# L.D.A. Services

**Re: Kariong Sand & Soil Supplies Facility (SSD-8660) – Public Submission Document**

### **Department of Planning, Industry & Environment Response to Independent Planning Commission (2<sup>nd</sup> December 2021)**

**Independent Planning Commission Letter to Department of Planning,  
Industry & Environment (22<sup>nd</sup> November 2021)**

Figure 1: AERMET meteorological data used in the model (left) vs. TAS anticipated nearby data (right)

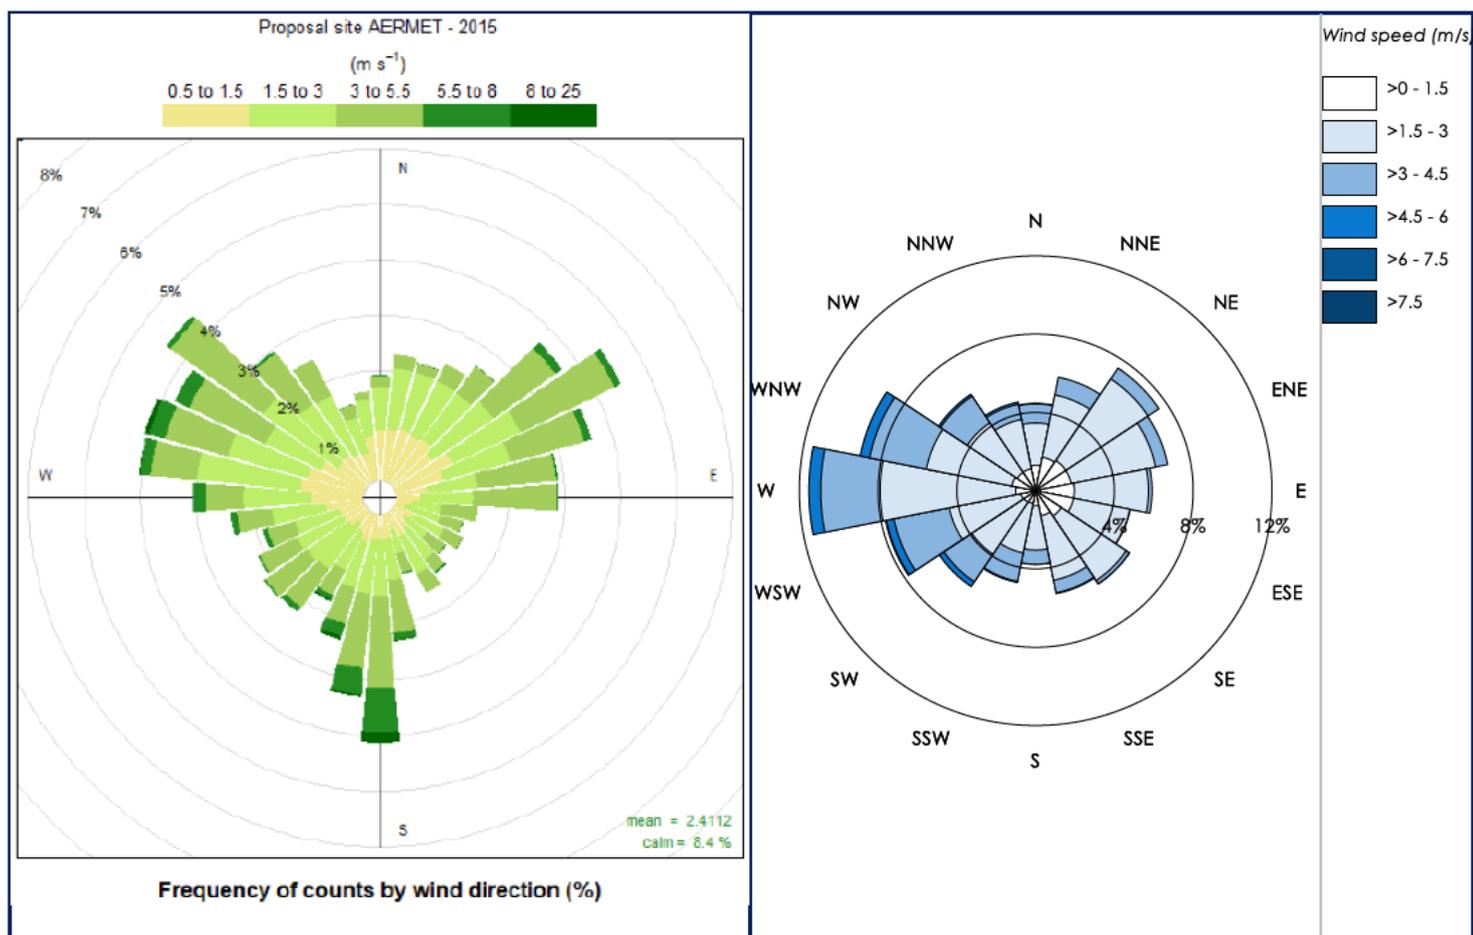
A comparison of the NorthStar meteorology used in the modelling and my own meteorology derived for a location nearby is set out in the figure below. The NorthStar windrose on the left uses 36 x 10 degree segments, and the TAS wind rose on the right uses the standard compass directions (16 x 22.5 degree segments).

It is significant that the figure shows the NorthStar data used in the modelling does not contain the predominant strong westerly winds reported by the residents modelling data but these winds do arise in the TAS wind rose. The NorthStar data shows approximately 4-5% of its westerly winds are above 3m/s, compared to approximately 14% in the TAS wind rose. This shows that the westerly winds of most relevance for assessing the impacts are underestimated by a factor of approximately three fold in terms of their frequency of occurrence. The modelling would thus significantly underestimate the frequency and amount of dust blowing towards residents due to wind erosion from the open stockpiles and open roads, and open material transport and handling areas.
